Subject: Submittal of Final Continuous Surface Water Monitoring Report 2000 - 2002,
Redstone Arsenal, Madison County, Alabama

U.S. Environmental Protection Agency (EPA) Region 4
Comments on:
Continuous Surface Water Monitoring Report 2000 – 2002,
Draft, dated August 2003
Redstone Arsenal, Madison County, Alabama,

**Continuous Surface Water
Monitoring Report 2000 - 2002**

**Response to U.S. Environmental Protection Agency (EPA) Region 4
Comments on
Continuous Surface Water Monitoring Report 2000-2002
Draft, dated August 2003
Redstone Arsenal, Alabama**

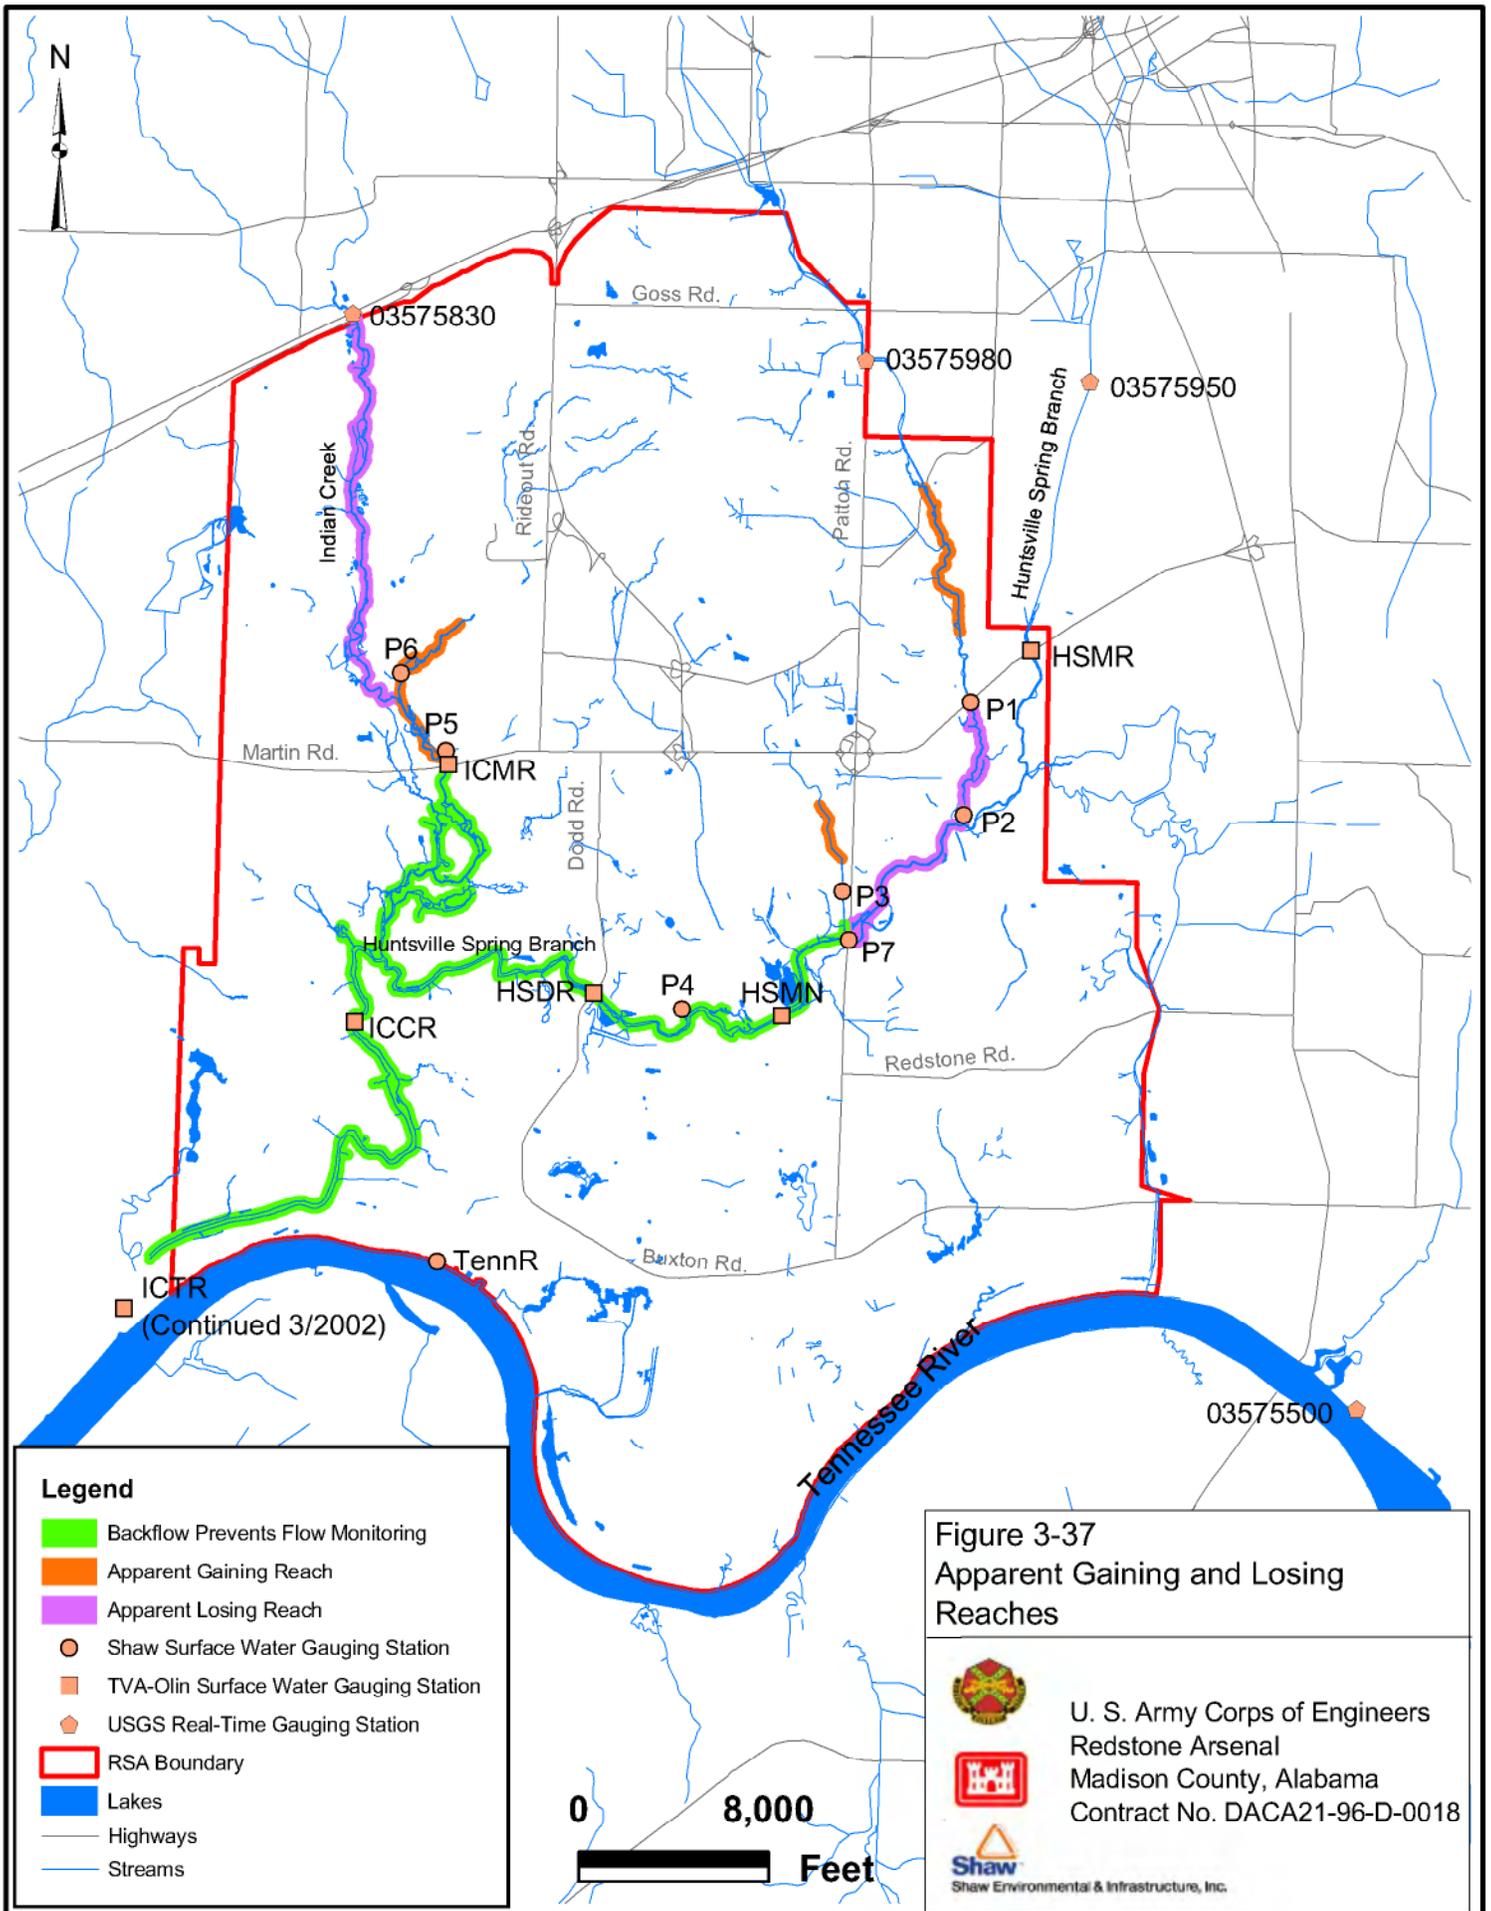
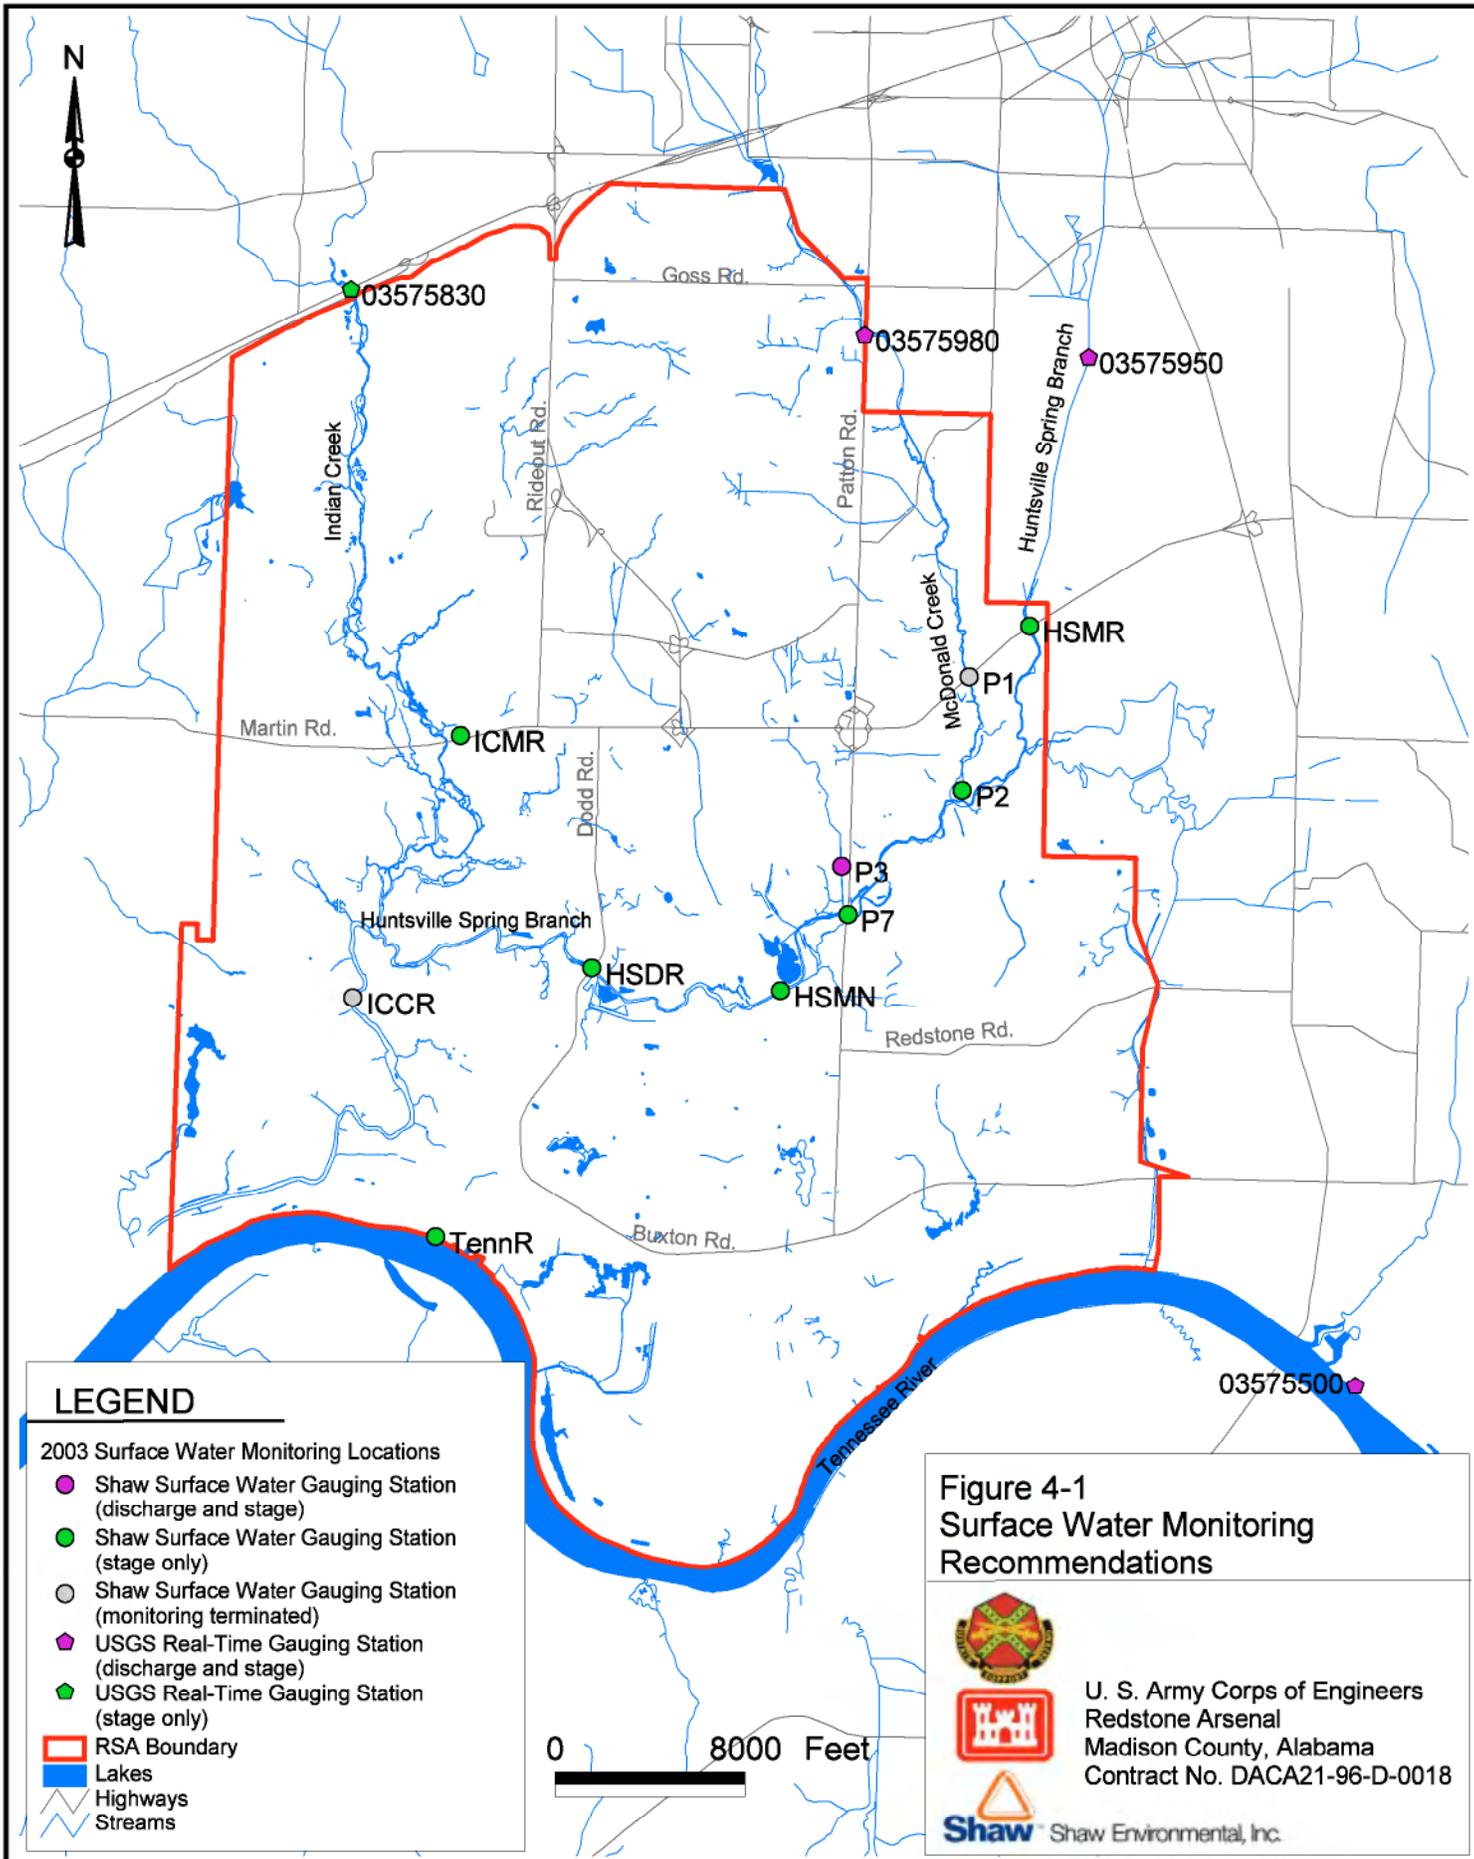
- 1) added text to Sections 2 and 3 (response to general comment #'s 2 & 3 and specific comment #2)
- 2) Figure 3-37 (response to general comment #2)

Comment 2: This report is full of the hydrographs and flow data that make up the basic data of surface water hydrology. The water freely interchanges between the groundwater and the surface water and thereby potentially discharging contaminants to the surface water and allowing dilution of plumes in the subsurface. It would be useful if there were a map which depicted the gaining and losing reaches of the major surface water bodies across the facility. This map would aid in the holistic understanding of the hydrology of Redstone Arsenal and the specific impacts from the individual sites. Perhaps the map should be presented as a pair of maps depicting high pool/low pool stages or wet season/dry season conditions.

Response 2: With few exceptions, it is not possible to identify gaining or losing reaches for the monitored streams at Redstone. Such determinations are hindered by backflow conditions in the downstream reaches of Huntsville Spring Branch/Indian Creek, sparcity of monitoring stations along upper Indian Creek, and issues regarding rating changes over time in several other gaged locations. In the case of Indian Creek upstream of Martin Road, the low gradient, braided meandering channel is not conducive to establishing monitoring stations. Consequently, it is not possible to identify gaining or

losing reaches between Martin Road and I-565. What is known is that there is a gaining reach along McDonald Creek downstream of the Hansen Road bridge, much of which can be attributed to discharge from several distinct springs. Additionally, and as described in the report, a losing reach exists along Huntsville Spring Branch between the confluence with McDonald Creek and the Patton Road bridge. Both of these conditions have been identified in the report. A single figure has been added to document the known reaches along Huntsville Spring Branch and McDonald Creek where gaining and/or losing conditions occur.
